<div>CONCESSION</div> <div>CONTINUATION SHEET</div>	Reference	TN-006536234
		Suffix	FW
		Revision	
		Page	2 of 2
		A/C Type	A350-900
		MSN	00790
<div>Description of Divergence</div> <div>V532-70357-202-00 MACHINED PANEL US V532-70166-200-00 BUTTSTRAP FR 20 US V532-70161-201-00 CFRP SHOVEL FWD US</div>		<div>Responsible Design Office Decision</div> <div>Reason for suffix FW: - Impacted drawing: V53124243 - Further work to be performed according to Sketches 3-4.</div>

TN-006536234

VIEW LOOKING OUTBOARD

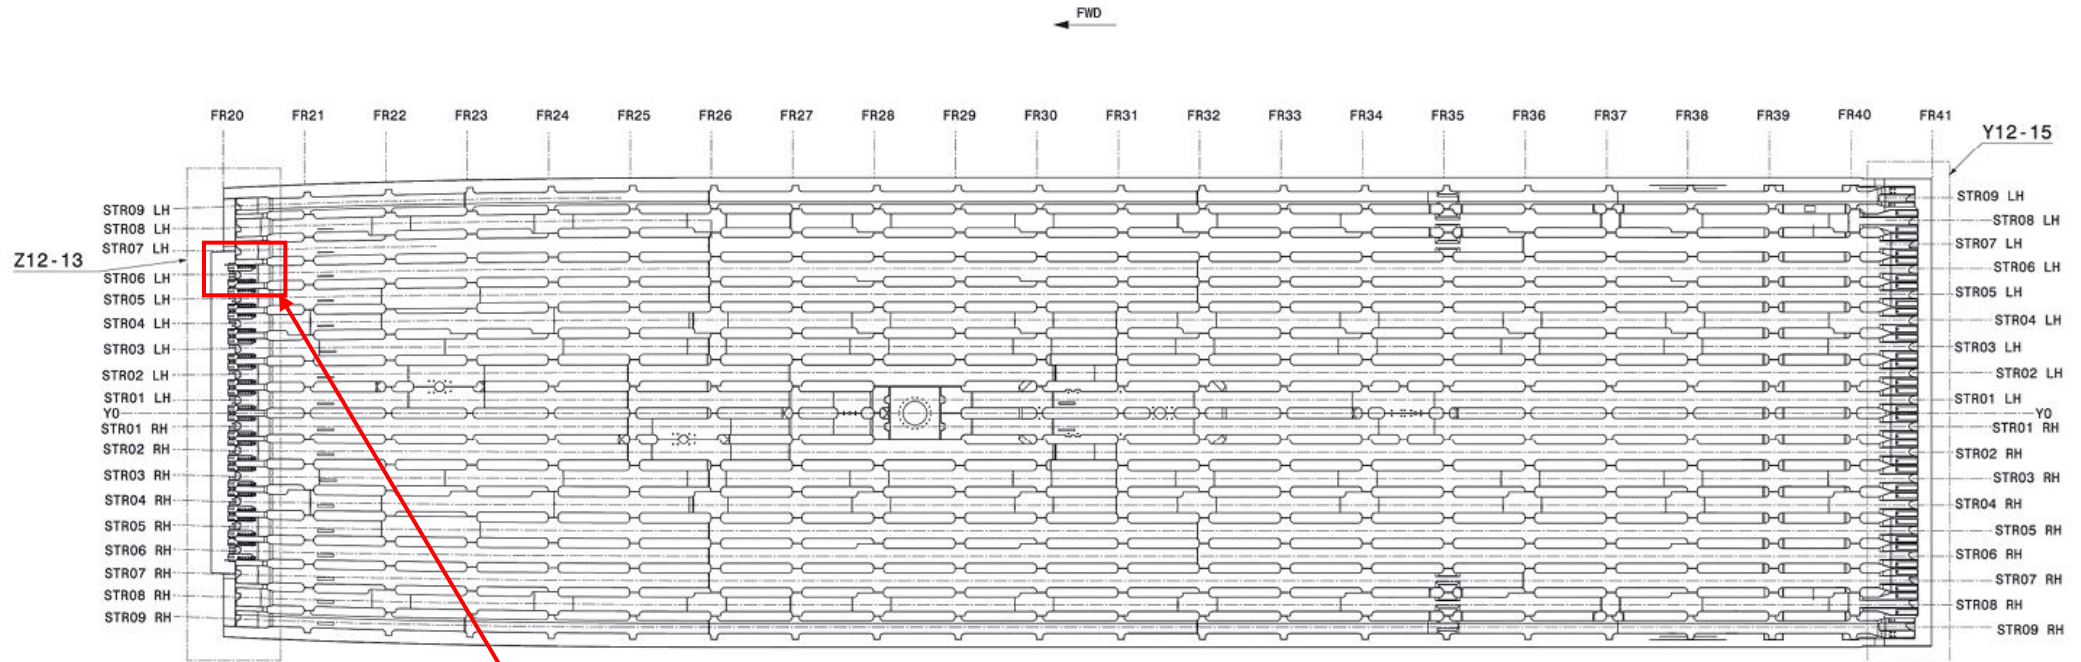
AFFECTED AREA - FRAME 20, STRINGER 06 LH - 07 LH

NONCONFORMITY: OVERSIZE HOLE DRILLED

DETAIL V13-14

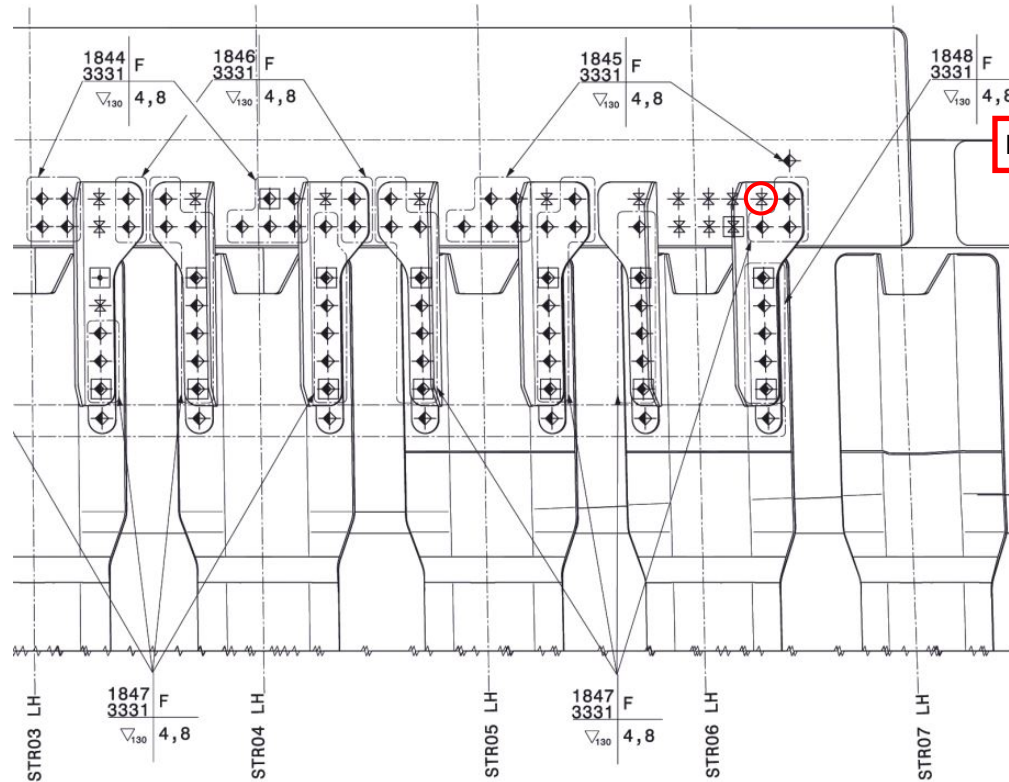
**NONCONFORMITY: 1x OVERSIZE HOLE DRILLED**

**SHOULD BE:**

**HOLE:**   $\rightarrow$  PILOT HOLE  $\varnothing 3,2\text{mm}$  H11

**IS:**

**HOLE:  $\varnothing 4,8$  (NO COUNTERSINK)**

**HOLE  $\varnothing 4,8$  DRILLED THROUGH "MACHINED PANEL US" AND "BUTTSTRAP FR 20 US"**

**HOLE DIAMETER IN "CFRP SHOVEL FWD US" IS  $\varnothing 3,2$**

**HOLE POSITION, EDGE DISTANCE, PITCH DISTANCE AND AFFECTED PARTS THICKNESS AS PER DRAWING.**

Figure 01

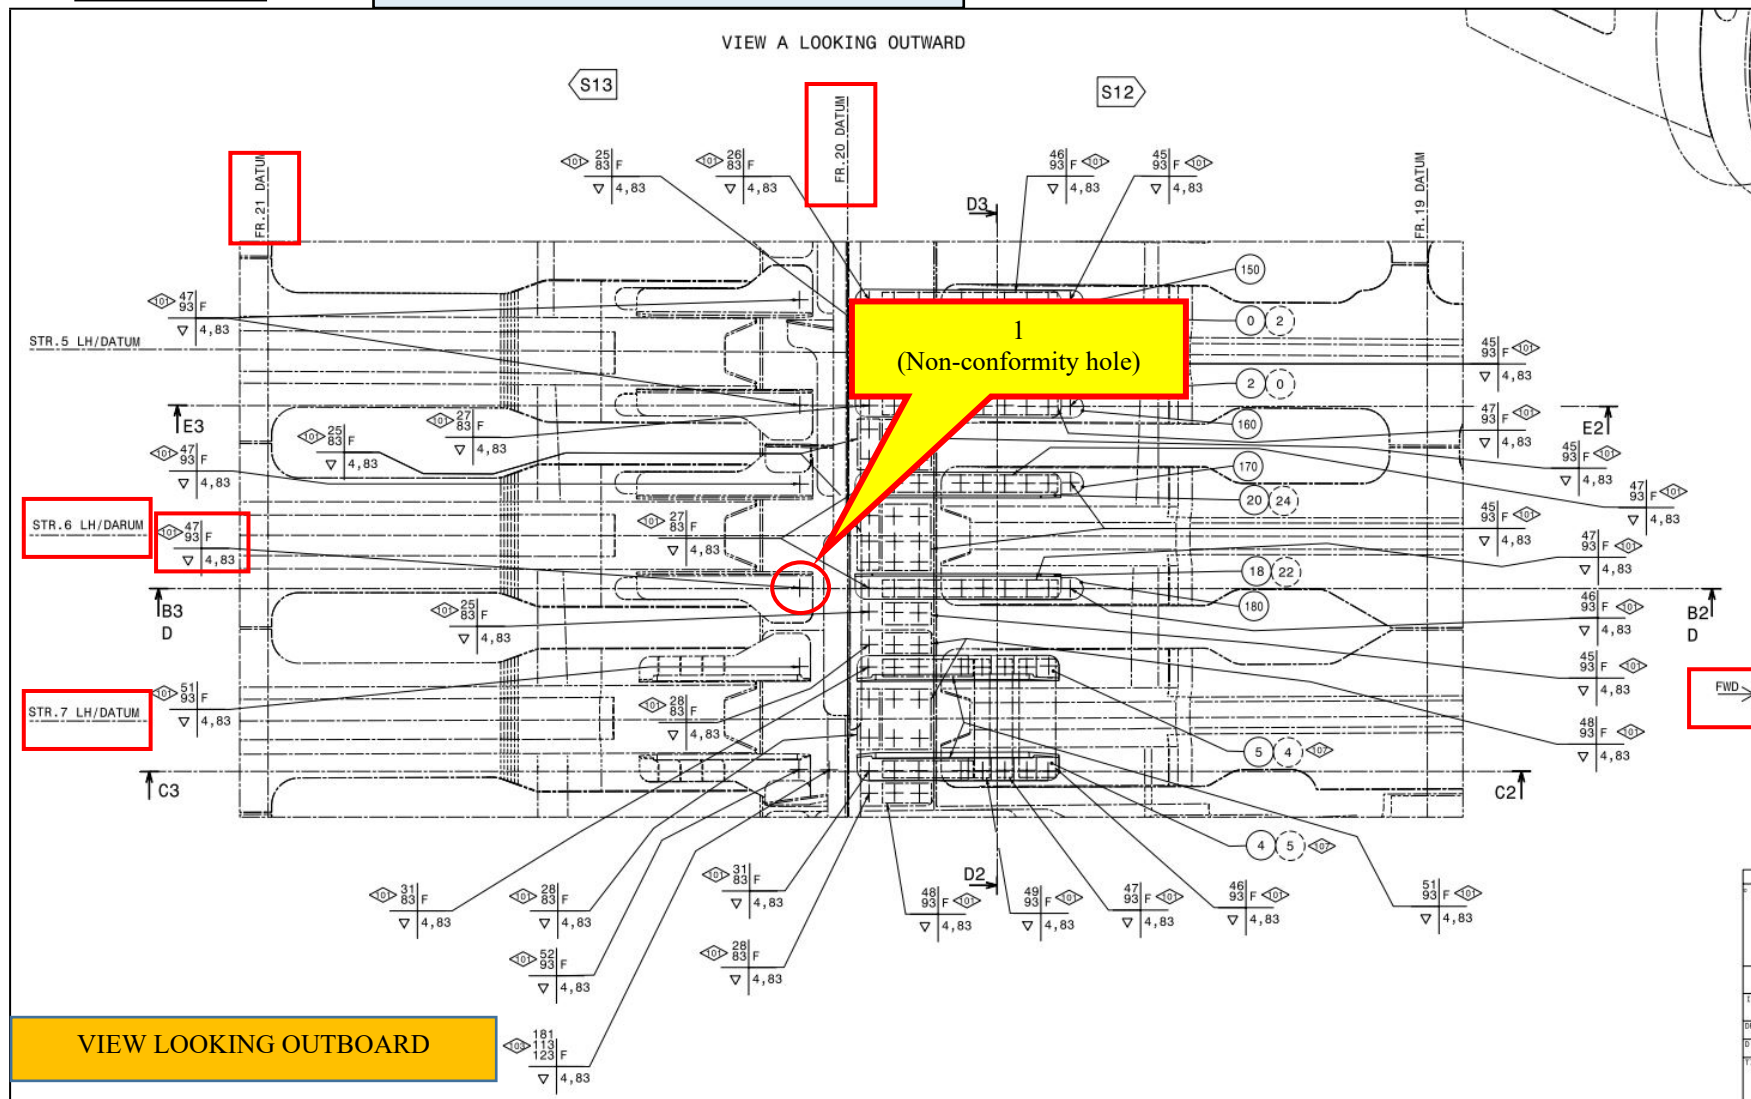
- Take into account that, 1 hole was drilled to Ø4,8mm instead of Ø3,2mm on MACHINED PANEL US, BUTTSTRAP FR 20 US and CFRP SHOVEL FWD US at assembly level while performing the operations as per drawing V53124243 (See Figure 01)
- Special care to be taken while pinning or drilling template installation at Pre-FAL level as per DS: V53124243
- Complete the installation and protection as per definition.

- Ream the non-conformity hole as per ABS1707BA0V3A geometry requirement through entire stack up.
- Complete the rest of installation as per nominal.
